BOARD OF WATER SUPPLY

Subject: Draft Synoptic Water Level Study Work Plan, Halawa Area, Oahu, Hawaii,
Prepared by the United States Geological Survey (USGS) Pacific Islands
Water Science Center Dated May 5, 2017

DRAFT Synoptic Water Level Study Work Plan
Hālawā Area, O‘āhu, Hawai‘i
U.S. Geological Survey, Pacific Islands Water Science Center
May 5, 2017

Figure 1. Proposed wells to be monitored during a three-month period of 2017, Hālawā area, O'ahu, Hawai'i.

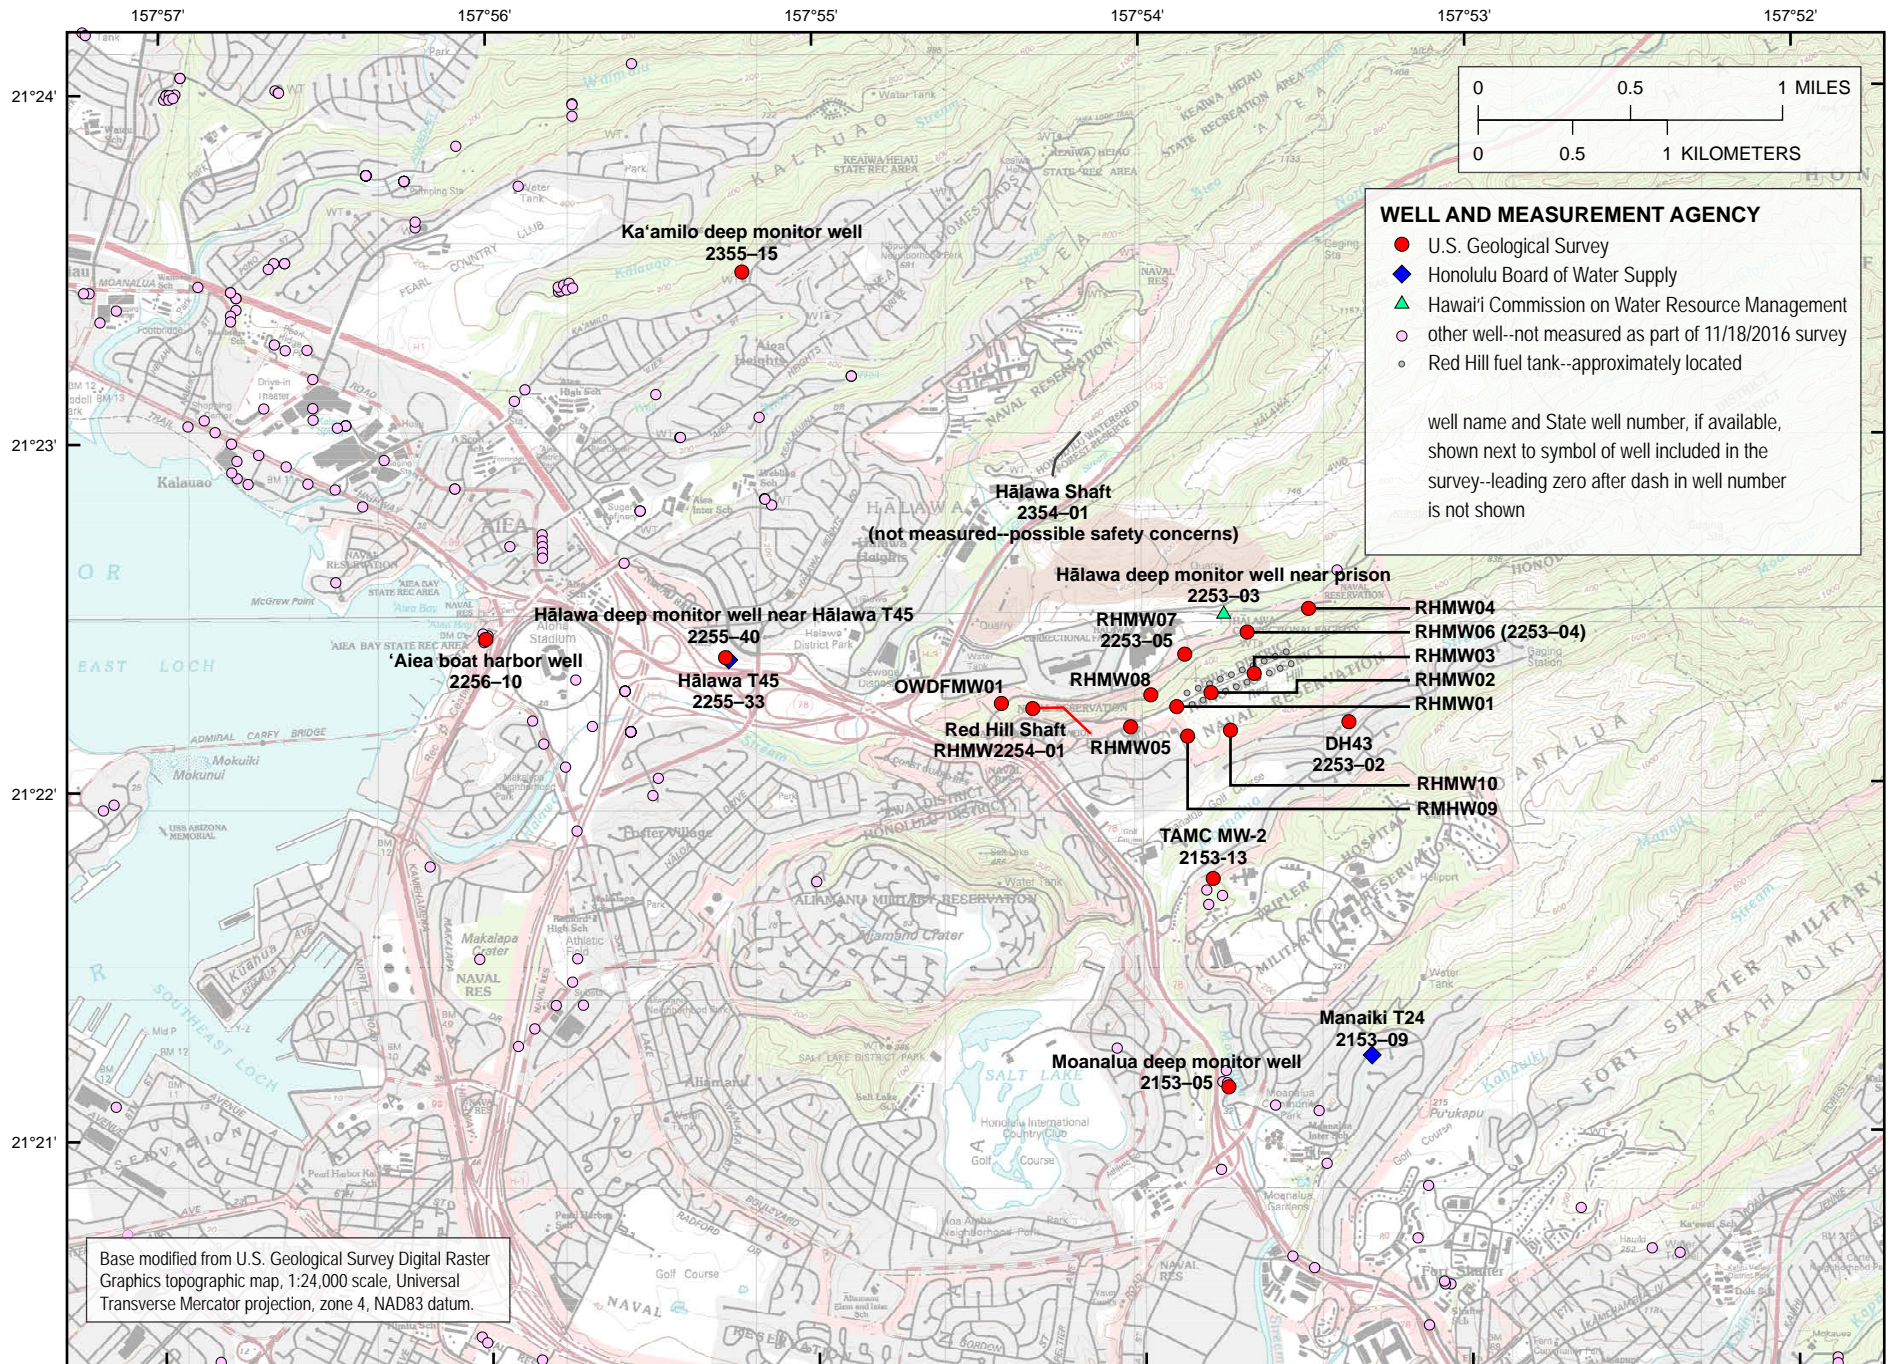
8. Figure 1 can be misleading in terms of well ownership. The BWS recommends including well owner information in parentheses, next to well IDs on Figure 1, or a separate figure showing well ownership.
9. Is the draft Work Plan going through legal review? Perhaps additional language is needed (e.g. all parties involved provide data or access to wells in a timely manner, USGS is the final reviewer and reporter of compiled water level data, etc.).

Figure 2. Proposed withdrawal rates from (A) Halawa Shaft, (B) Red Hill Shaft, and (C) Moanalua Wells during a three-month monitoring period, 2017.

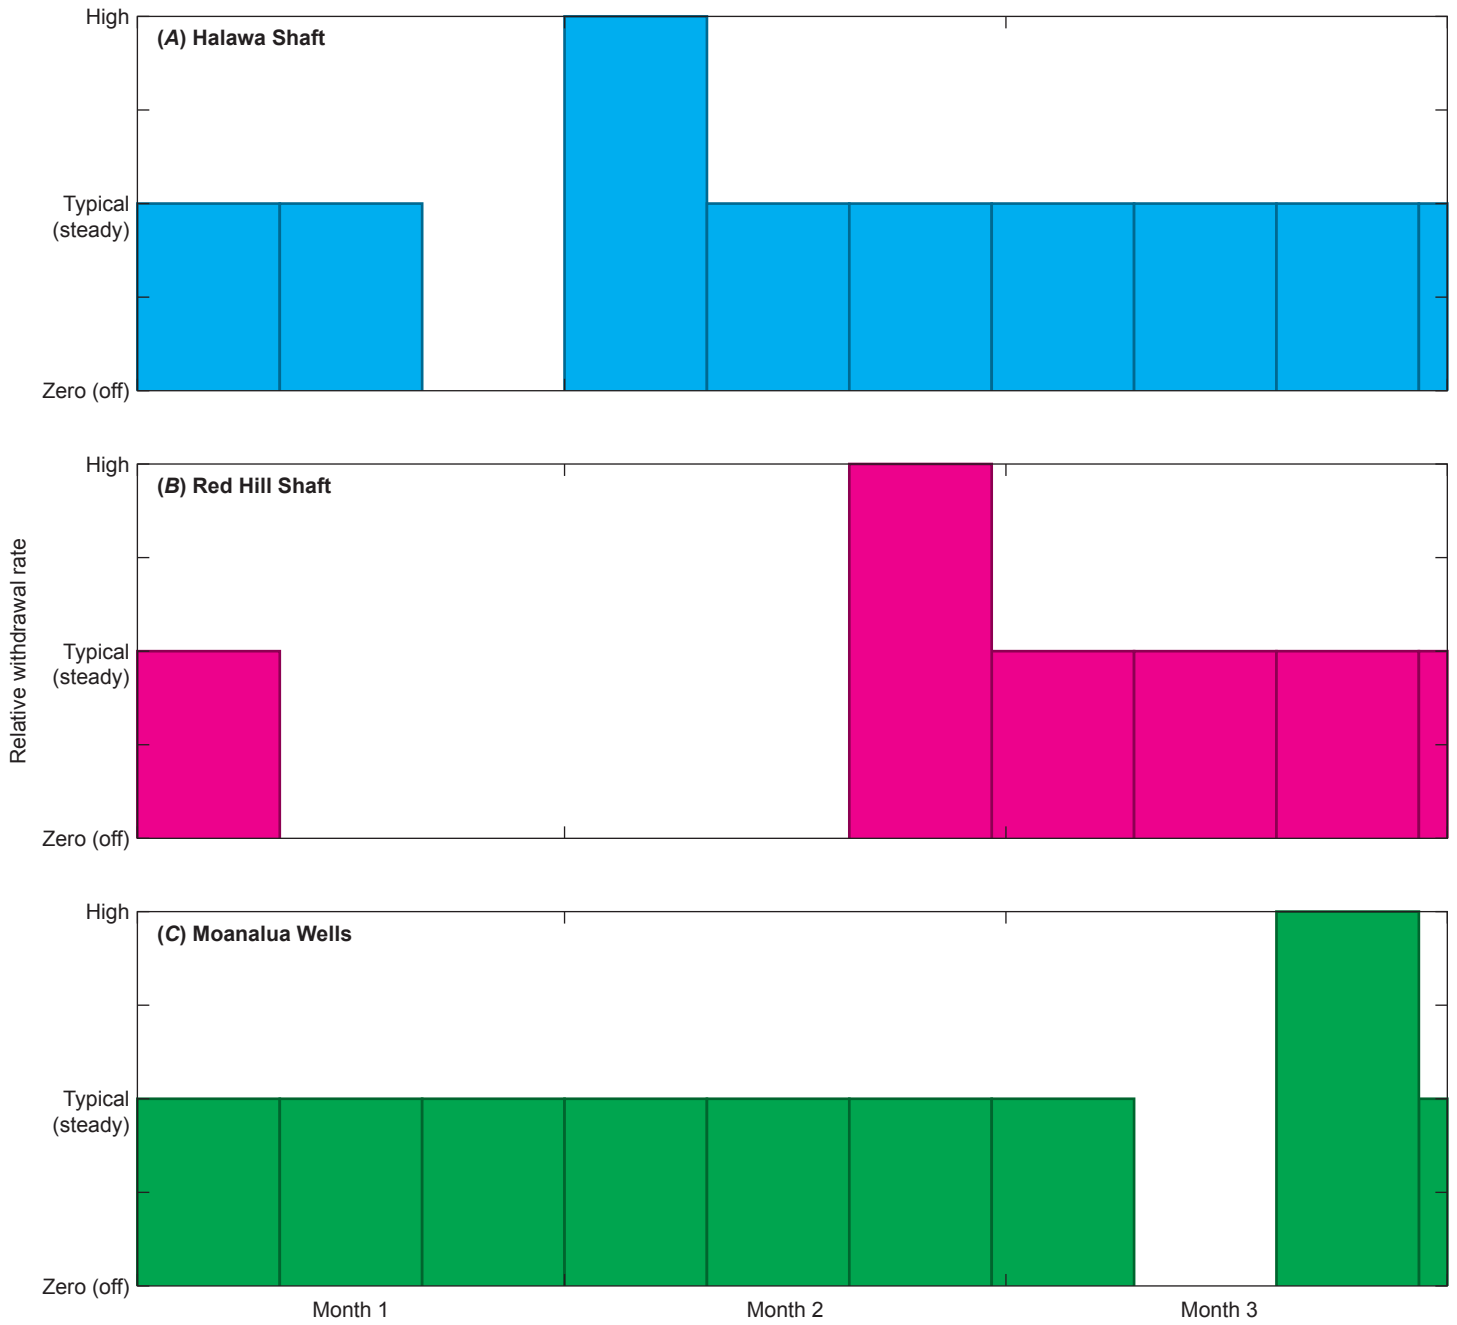
4. The Board of Water Supply (BWS) has reviewed the graph showing the proposed groundwater withdrawal rates from Halawa Shaft and Moanalua Wells for the study period. The BWS is prepared to pump Halawa Shaft at a typical rate (10 million gallons per day [mgd]) and a high rate of 14 mgd during the Work Plan's proposed time period subject to our operational schedule and needs at the time of the test. Likewise, the BWS is also prepared to pump BWS Moanalua Wells at a typical rate of 2.5 mgd and a high rate of 5 mgd during the Work Plan's proposed time period subject to our operational schedule and needs at that time. Please contact Erwin Kawata at 808-748-5080 to coordinate BWS pumping operations. The Work Plan does not specify the typical and high rates of pumping for both Halawa Shaft and Moanalua Wells. Please provide further clarification.

5. Has the Navy committed to the pumpage study and at what typical and high rates will they pump Red Hill Shaft? Depending on what the withdrawal rates will be at Red Hill Shaft, this may require an adjustment to the withdrawal rates for Halawa Shaft and Moanalua Wells during the study period. Please clarify.
